DEPARTMENT OF PLANNING AND COMMUNITY DEVELOPMENT

February 2, 2012

08-CUP-002 and TPM 69698

28700 Thousand Oaks Boulevard

VICINITY MAP **GRADING & DRAINAGE**

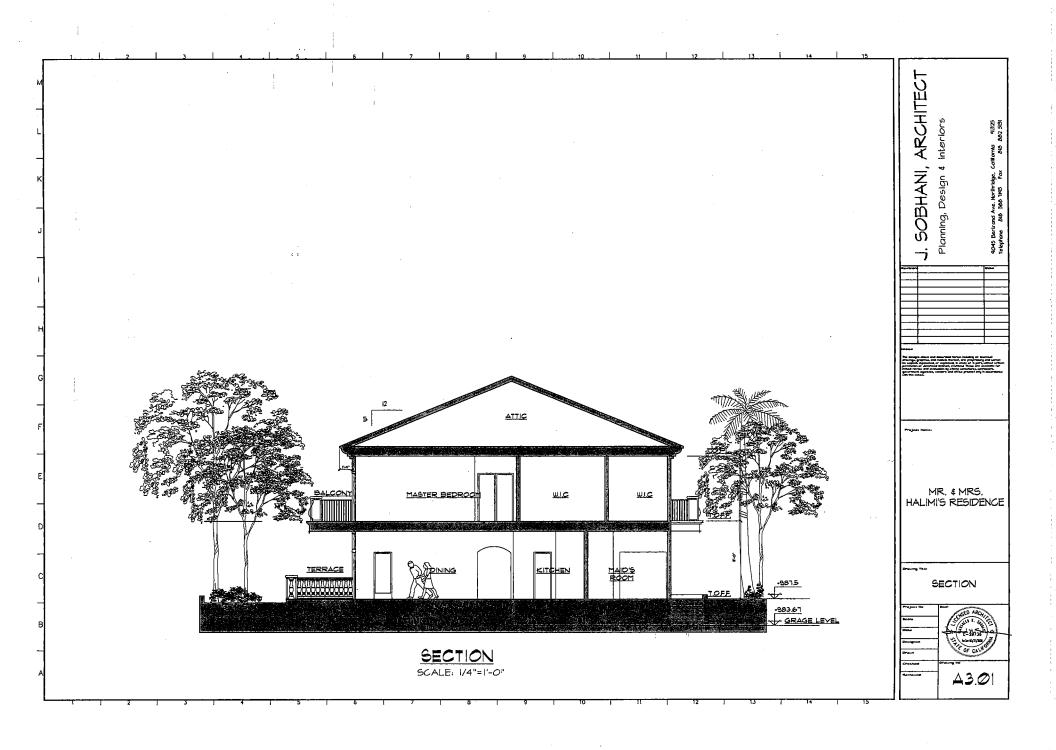
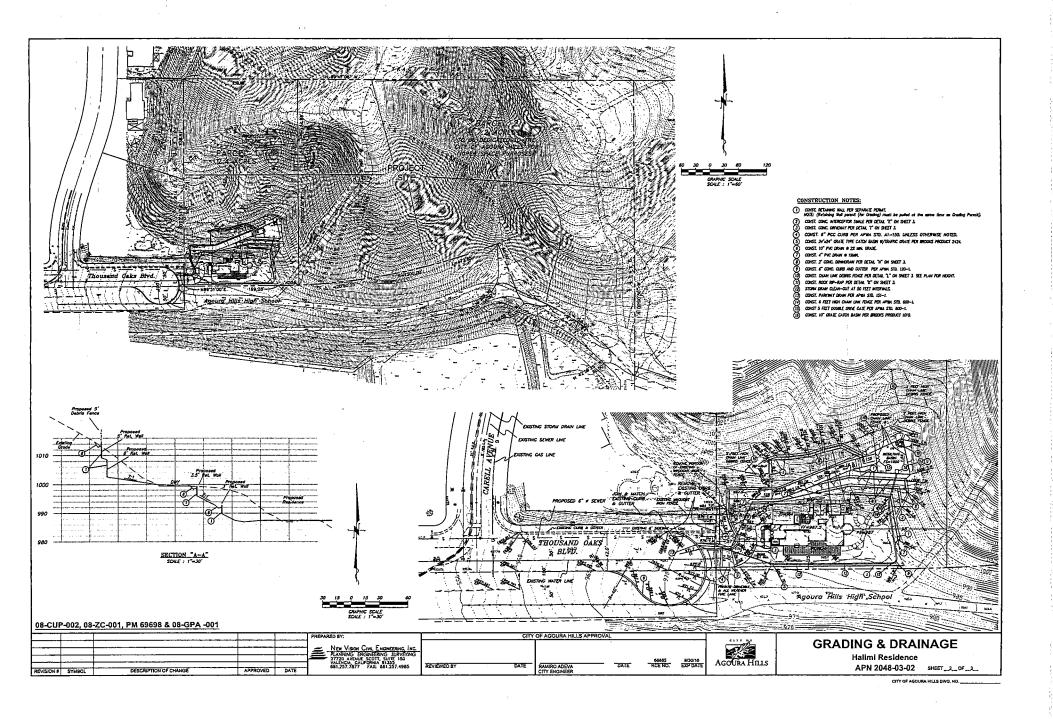
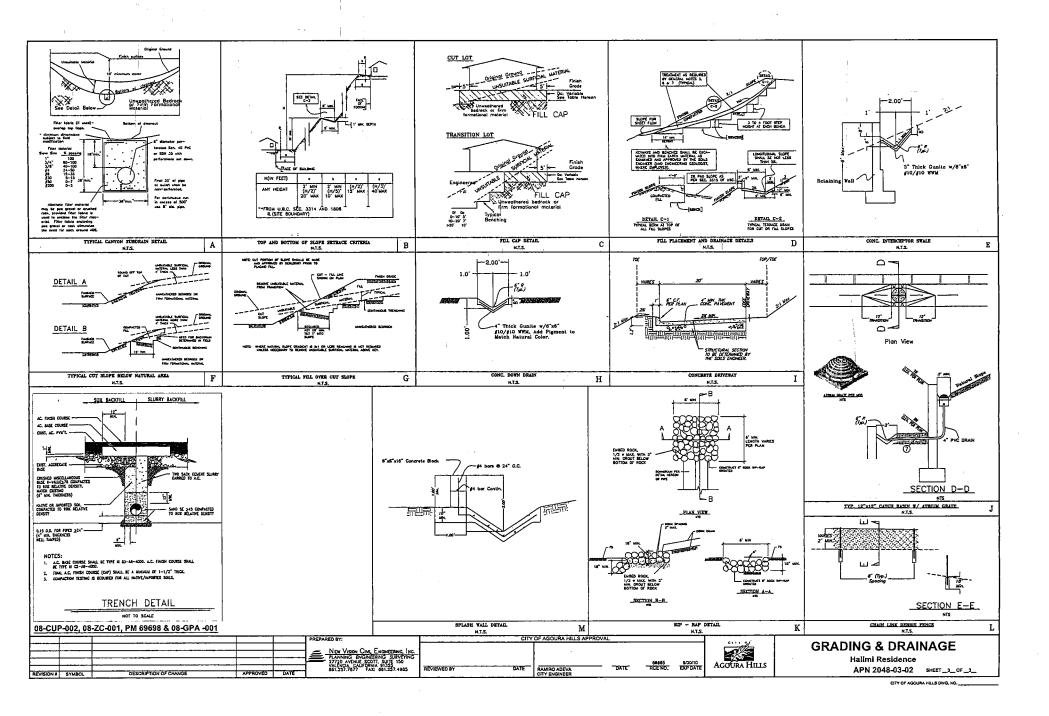
- 1. The name, address, and phone number of the Consultant and a list of all the applicable geotechnical reports shall be included on the building/grading plans.

- 2. The following note must appear on the grading and foundation plans: "All retaining wall excavations shall be reviewed by the project engineering geologist for the presence of adversely oriented joint surfaces. Adverse surfaces shall be evaluated and supported in accordance with recommendations of the project geotechnical engineer."

- 3. The grading plan should include the limits and depths of overexcavation for the swimming pool, the road and flatwork areas as recommended by the Consultant.

- 4. The following note must appear on the grading and foundation plans: "Excavations shall be made in compliance with CAL/OSHA Regulations."
- 5. The following note must appear on the foundation plans: "All foundation excavations must be observed and approved, in writing, by the Project Geotechnical Consultant prior to placement of reinforcing steel."

- 6. Foundation plans and foundation details shall clearly depict the embedment material and minimum depth of embedment for the foundations.
- 7. Drainage plans depicting all surface and subsurface non-erosive drainage devices, flow lines, and catch basins shall be included on the building plans.

- 8. The consultant should review and approve final debris flow mitigation plan.
- 9. Final grading, drainage, and foundation plans shall be reviewed, signed, and wet stamped by the consultant.

10. Provide a note on the grading and foundation plans that states: "An as-built report shall be submitted to the City for review. This report prepared by the Geotechnical Consultant must include the results of all compaction tests as well as a map depicting the limits of fill, locations of all density tests, outline and elevations of all removal bottoms, keyway locations and bottom elevations, locations of all subdrains and flow line elevations, and location and elevation of all retaining wall backdrains and outlets. Geologic conditions exposed during grading must be depicted on an as-built geologic map."

APN2048~03~02 PRELIMINARY LANDSCAPE PLAN

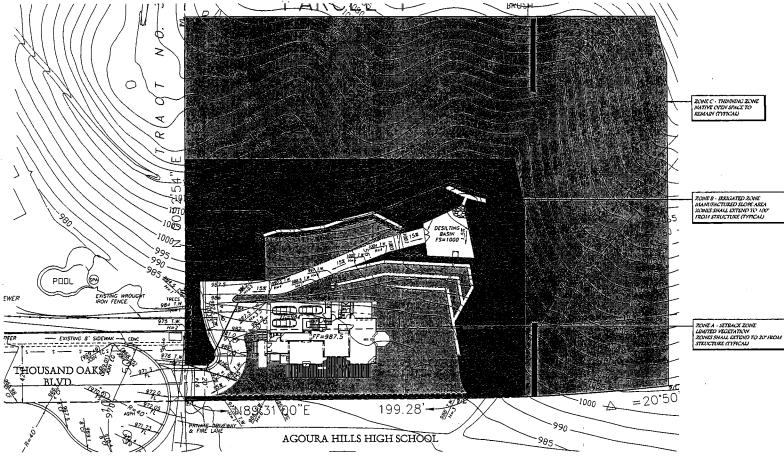
- 70. The plant material near the house, indicated by the dotted hatch, has not been identified on the plans. The applicant's landscape architect shall identify this plant material.

- 71. The applicant shall plant vines at the foot of the south facing retaining wall located near the southerly property line to provide screening of the wall.
